TRUCK UTILITY 3/4 TON, GS, FFR, LANDROVER  
REAR BODY FLOOR  
UNIT REPAIR

FIG. 1 -- RIBS UNDER REAR BODY FLOOR

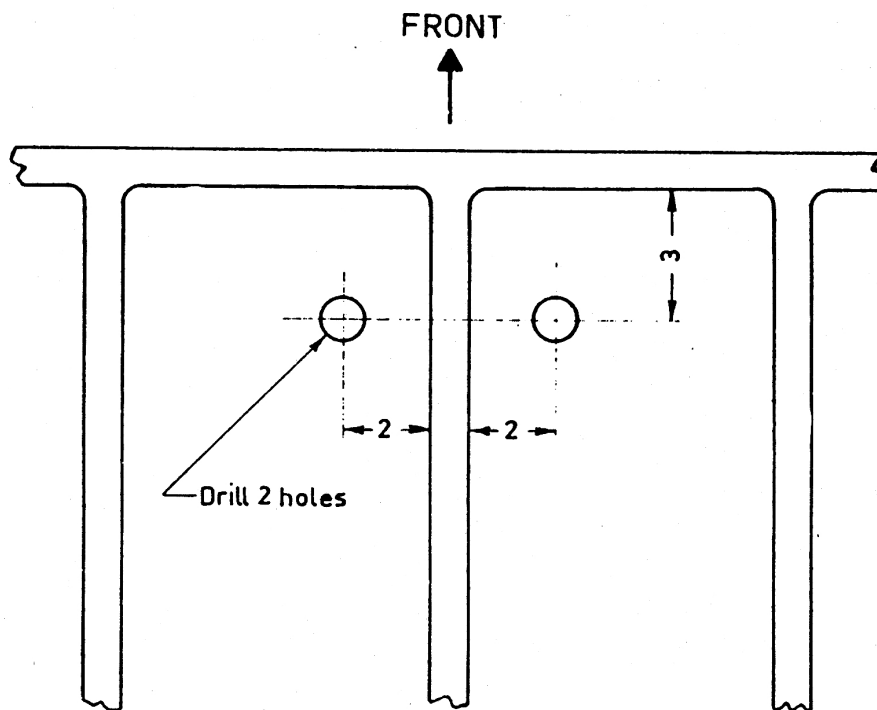
1. This instruction supersedes DEME BULLETIN 20/68, and details the drilling of the rear body floor of vehicle to prevent an accumulation of water causing damage to the C.A.V. suppression box mounted on the rear body front panels.

2. From under the vehicle drill two 1/2 inch diameter holes in the positions shown in Fig 1.
